Service Bulletin: SB 407-301; Bell Helicopter Air Conditioner Compressor Drive Ring & Pulley Up-grade.

Subject: Up-grade of air conditioner Compressor Drive Ring & Pulley.

Date: 18 December, 2002, Rev, N/C

Applicability: Bell 407 Helicopter, Equipped with the Air Comm Corporation 407EC-201 Air Conditioning System.

Figure 1-1 Installation of Compressor Drive Pulley and Drive Ring Assembly

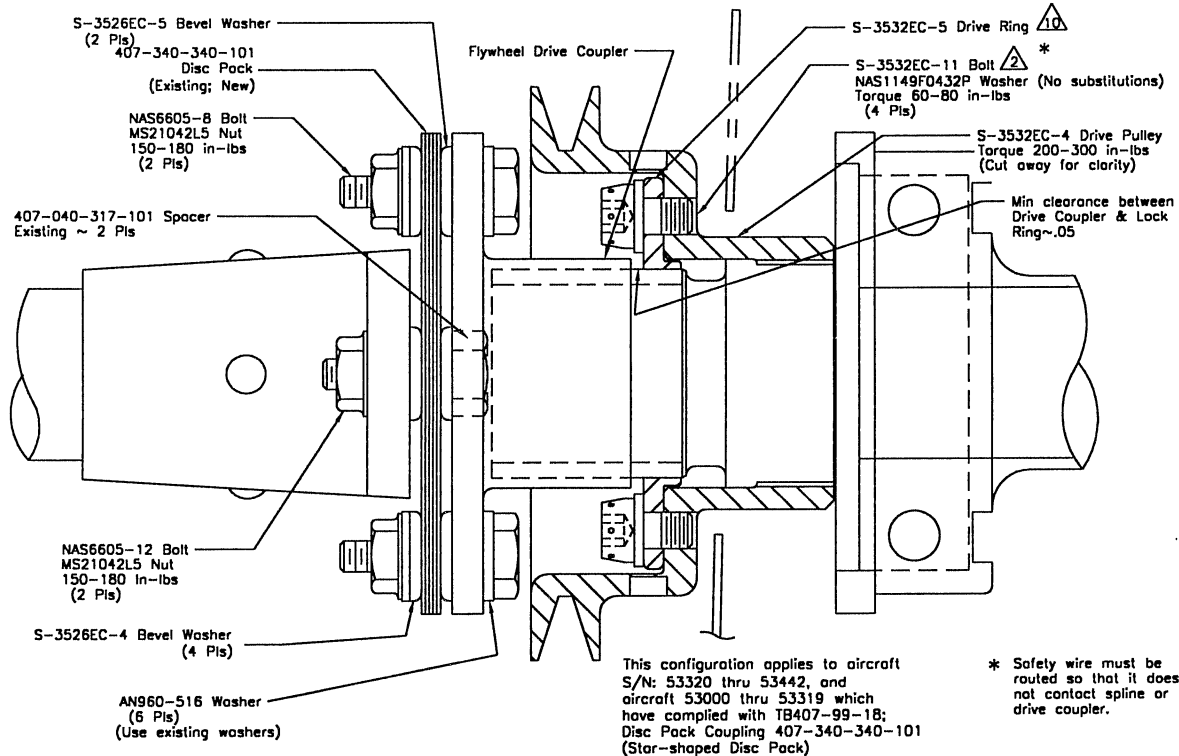
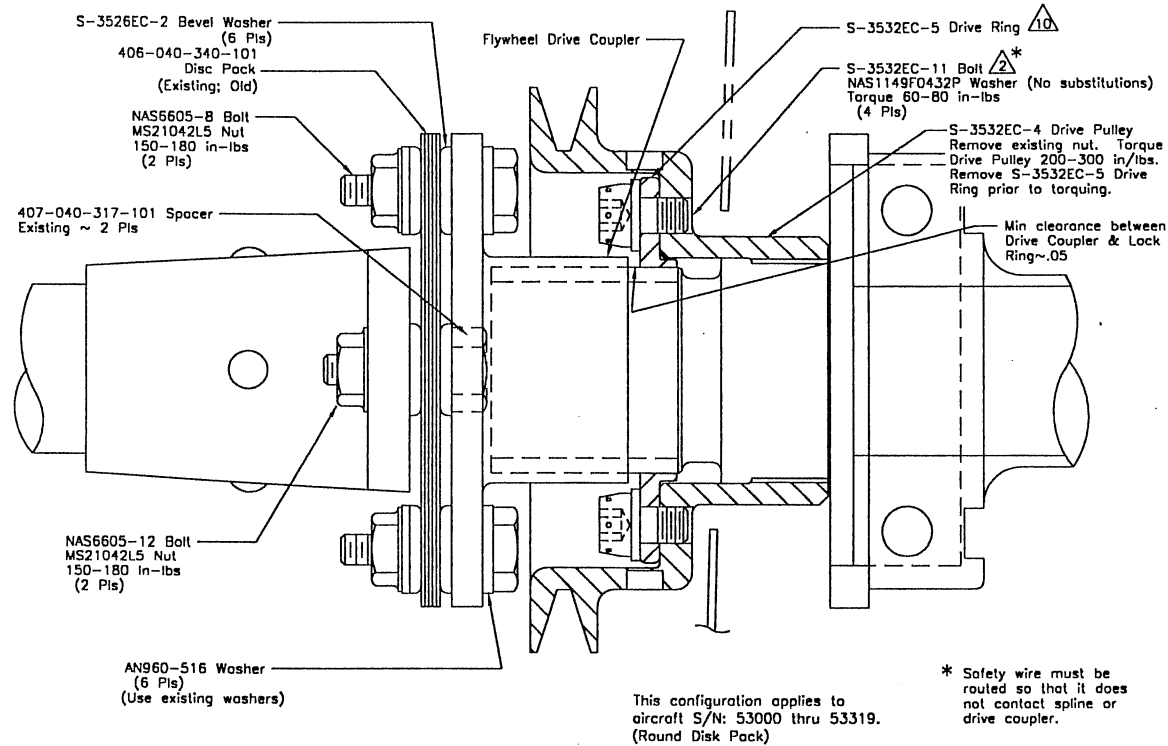
ACC has redesigned these components to allow additional Drive Ring & Pulley adjustment to insure the proper torque is applied to the Drive Pulley Assembly, as well as increase the spline surface area contact to better distribute the drive load from the driveshaft assembly.

To replace the existing air conditioner Compressor Drive Ring and Pulley Assembly with parts designed to aid in the installation, torquing procedures of these components.

- A. Install the new Compressor Drive Pulley S-3532EC-4 on the Tail Rotor Driveshaft, threading the pulley tightly against the face of the Driveshaft Hanger Bearing Retainer.

- B. Torque the S-3532EC-4 Compressor Drive Pulley to 200 – 300 in lbs (22.59 – 33.89 Nm), using a .257 Dia X .13 Deep Spanner Wrench, utilizing one of the (4) four available holes on the pulley body.
- C. Install new Drive Ring S-3532EC-5 on to the Driveshaft Spline, and slide into place aligning four (4) of the twelve holes provided in the Drive Ring with four (4) of the twelve (12) threaded holes located in the Compressor Drive Pulley. (See note 10).

- D. Once the correct hole alignment is accomplished between the Drive Ring and the Compressor Drive Pulley. Install the four (4) S-3532EC-11 Bolts and AN960-PD416 Washers and torque to 60 – 80 in lbs. (6.77 – 9.03 Nm) and safety bolts using .032 safety wire (See note 2).

Figure 1-2, Installation of Aft Firewall Placard(s)

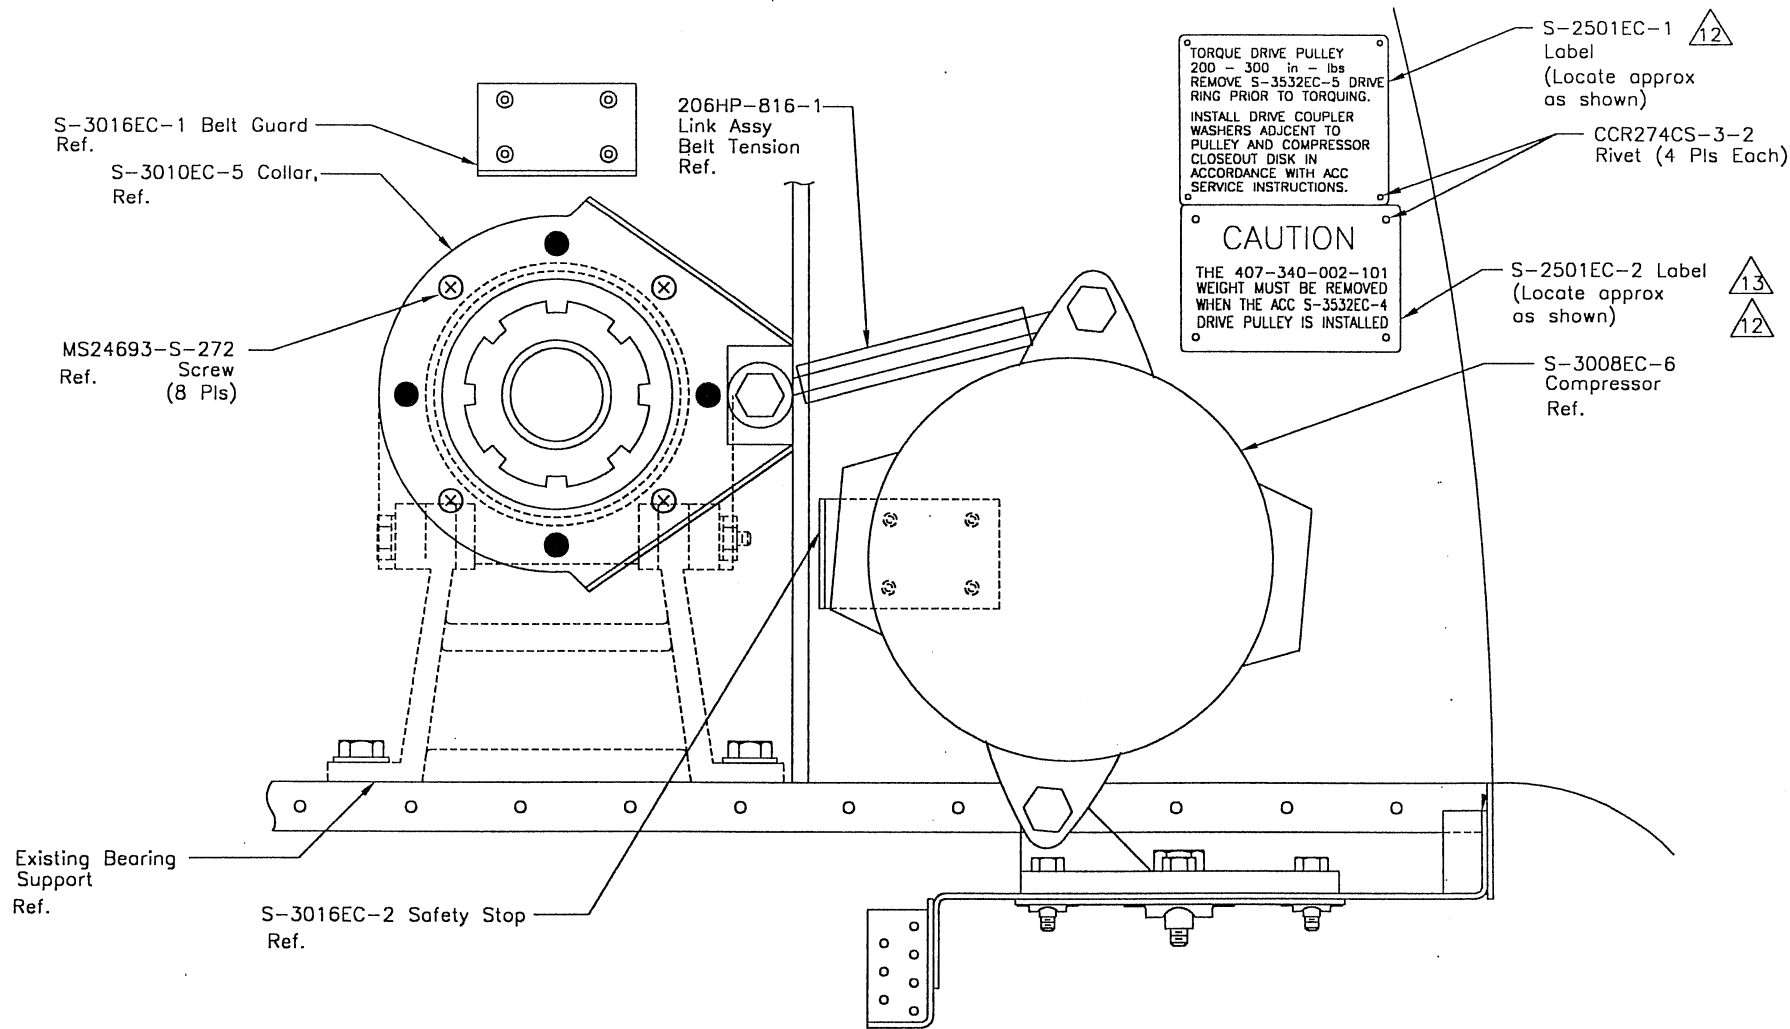
- A. Install new Placard(s) (P/N S-2501EC-1 & S-2501EC-2) (See Note 13) Approximately as shown in Figure 1-2, using four each CCR274CS-3-2 Rivets (See Note 12).
